Transition of Expeditionary EA-6B Prowler Squadrons to EA-18G Growler

Appendix B Agency Correspondence

Appendix B, Agency Correspondence

Enclosures: 1. Figure showing the various Action Alternatives 2. Map showing the APE

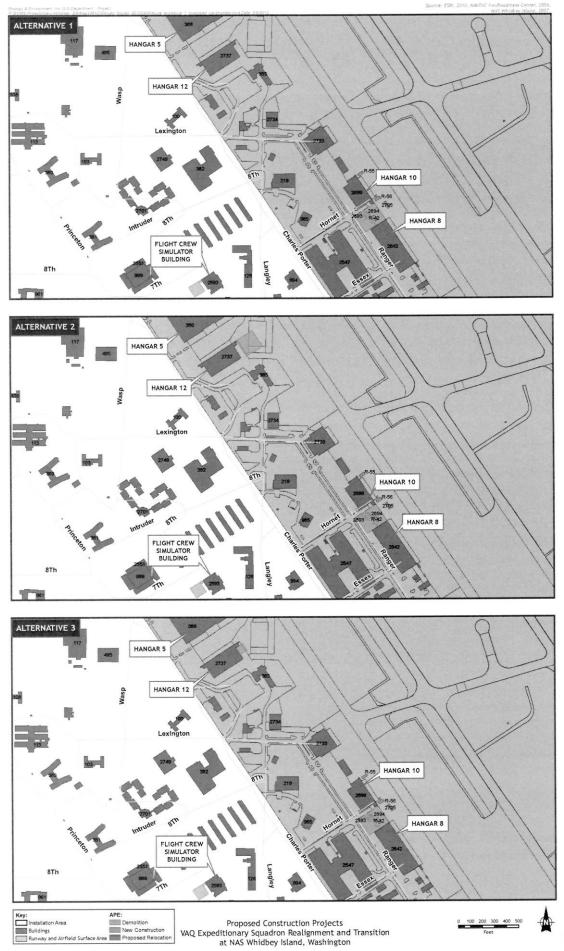
Enclosure (1) is a figure showing the facility modifications that would occur under the three action alternatives. These modifications include:

a. Alternative 1

(1) Demolition of four auxiliary buildings (R-42, R-55, R-56, and 2705).

(2) Relocation of two auxiliary buildings (2893 and 2894) from their current locations between Buildings 2699 and 2642 (Hangar 8) to an as yet unidentified, but previously disturbed area, between Buildings 2699 and 2737 (Hangars 10 and 12 respectively).

(3) Construction of an approximately 32,500-squarefoot addition to Building 2699 (Hangar 10) that will likely connect to Building 2642 (Hangar 8).

(4) Construction of an approximately 9,200-squarefoot addition, with a covered walkway, for Building 2593 (Flight Simulator Building).

b. Alternative 2. Alternative 1 plus construction of an approximately 25,200-square-foot addition to Building 2737 (Hangar 12) would be constructed.

c. Alternative 3. Alternative 1 plus an approximately 4,300-square-foot addition to Building 2737 (Hangar 12) would be constructed.

Area of Potential Effect is shown in light red. Reference is USGS Oak Harbor 7.5 map.

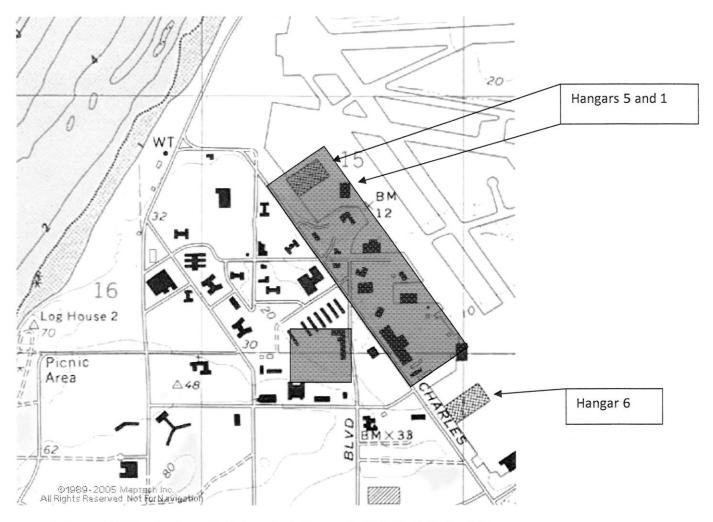
The Area of Potential Effect (APE) for this undertaking is shown in enclosure (2). Of the ten buildings included in the action alternatives, four have been previously evaluated and determined not eligible for listing in the National Register of Historic Places (Reference Log # 012610-05-USN). These include 2593 (Flight Simulator), 2642 (Hangar 8), 2699 (Hangar 10), and 2737 (Hangar 12). Buildings 2705, 2983, and 2894 do not need evaluations as they are less than 50 years old, built in 1986, 2006, and 2006 respectively. Buildings R-42, R-55, and R-56 are temporary buildings and are not eligible to the National Register of Historic Places.

Ault Field has four historic properties: Hangars 1, 5 and 6, and the base theater. Hangars 1 and 5 are adjacent hangar 12 and are within the APE. Hangar 1 is scheduled for demolition in FY14 and all action alternatives assume that it will be demolished. Mitigation for that action was included in the memorandum of agreement regarding demolition activities signed between your office and the Navy on June 2, 2010. Hangar 6 and the theater are outside the APE for this action.

Under Action Alternative 2, the proposed addition to the northeast end of Hangar 12 would be approximately 25,200 square feet and would be visible in views from or of the rear of Hangar 5. Under Action Alternative 3, the proposed addition to the northeast end of Hangar 12 would be approximately 4,300 square feet and would be almost entirely screened in views from, or toward the rear of Hangar 5 by the northeastern doorway for Hangar 12.

The Navy has concluded that Action Alternatives 2 and 3 would have No Adverse Effect on Hangar 5 because the setting of this building has not been identified as contributing to the significance of this building and because changes to the setting, which would only be visible from, or toward the rear of the hangar, would not affect those architectural design qualities that make it eligible for listing in the NRHP.

First, I agree with the Area of Potential Effects (APE) as described in your consultation letter. I also concur that each of the proposed alternatives for new construction and non-historic structures will have "NO ADVERSE EFFECT" on National Register eligible or listed historic and cultural resources. I would appreciate being notified of the designated Alternative once it is selected. If additional information on the project becomes available, or if any archaeological resources are uncovered during construction, please halt work in the area of discovery and contact the appropriate Native American Tribes and DAHP for further consultation.
